GULF STATES UTILITIES COMPANY

March 29, 1984

Pursuant to recent discussion with your Mr. E. Weinkam, enclosed is additional information on the solid radwaste system for River Bend Station. This information includes a revised flow diagram and text to indicate the ventilation provided for the system, and revised equipment arrangement drawings. This information will be reflected in a future FSAR amendment.

RADIOACTIVE SOLID WASTE SYSTEM
P & ID

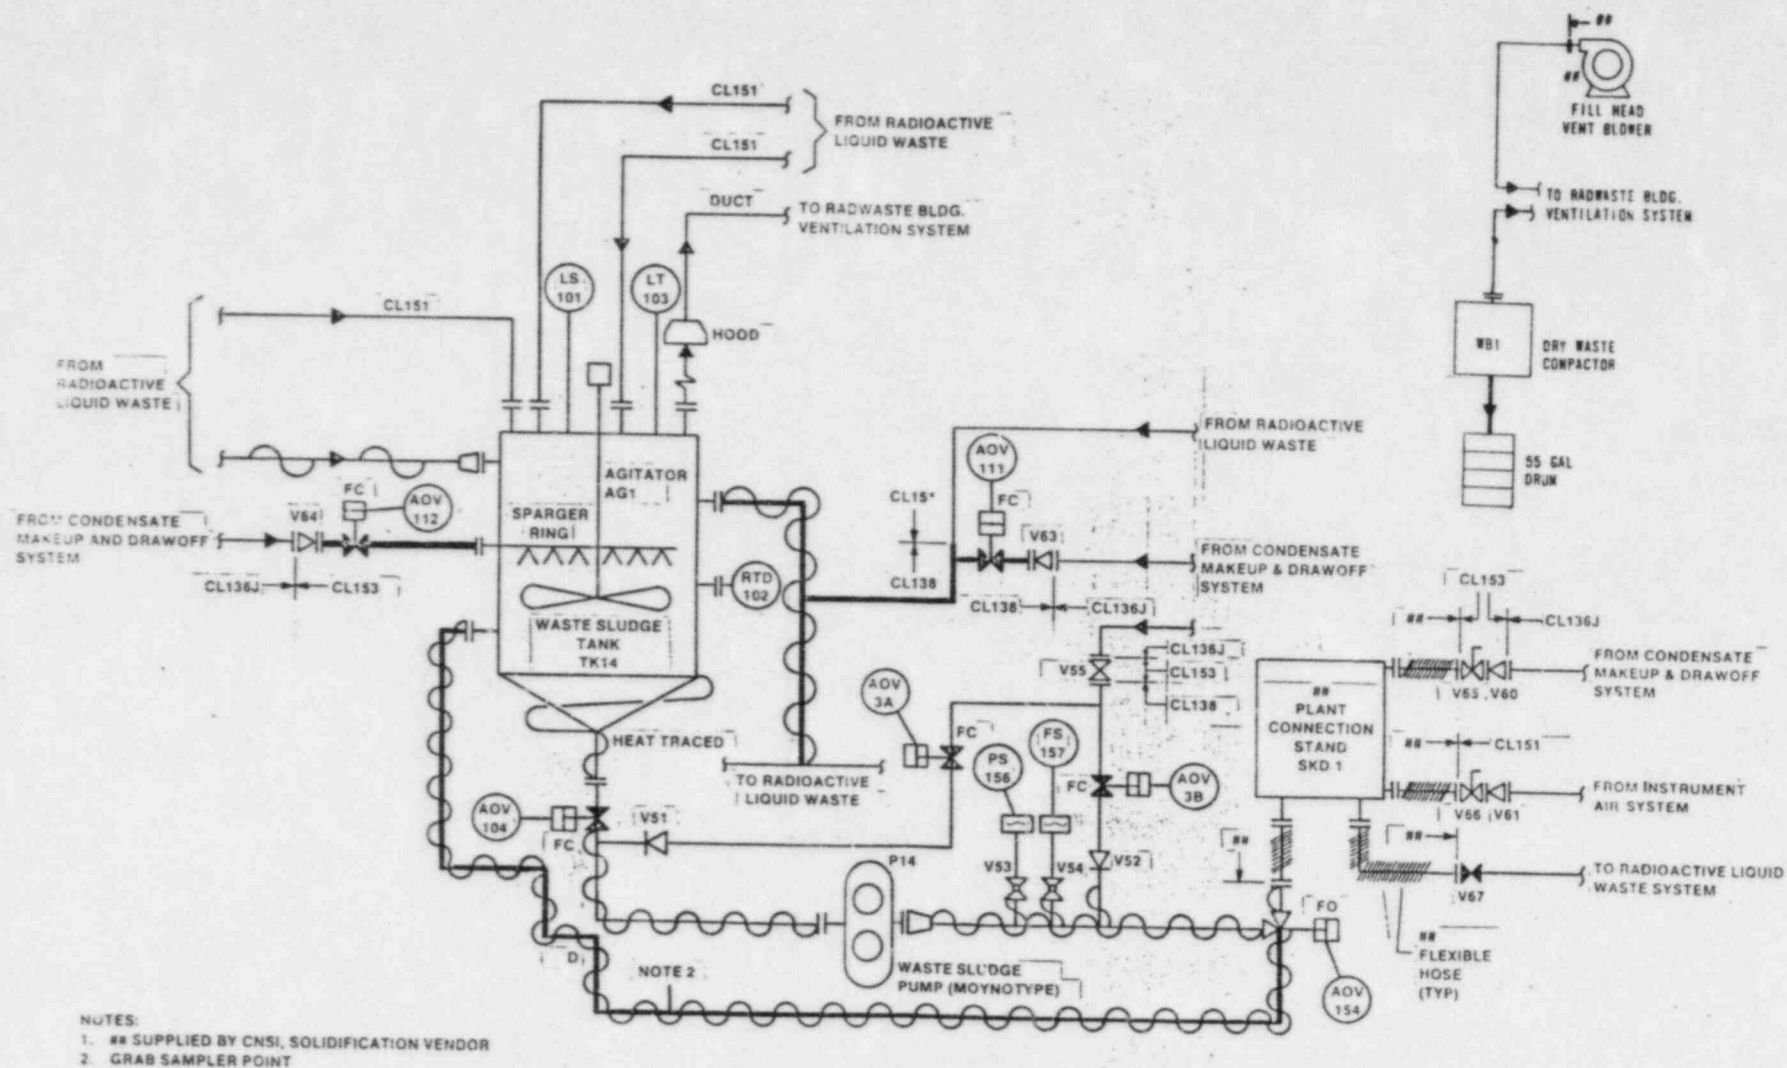
Attachment 2 is a flow diagram for the solid radwaste system that indicates the ventilation provided for the CNSI equipment.

8. Providing curbs to contain spills.
9. Compliance with Regulatory Guide 8.10, as indicated in Section 1.8.
10. Potentially contaminated exhaust air from the CNSI solidification equipment is routed to the radwaste building ventilation system.
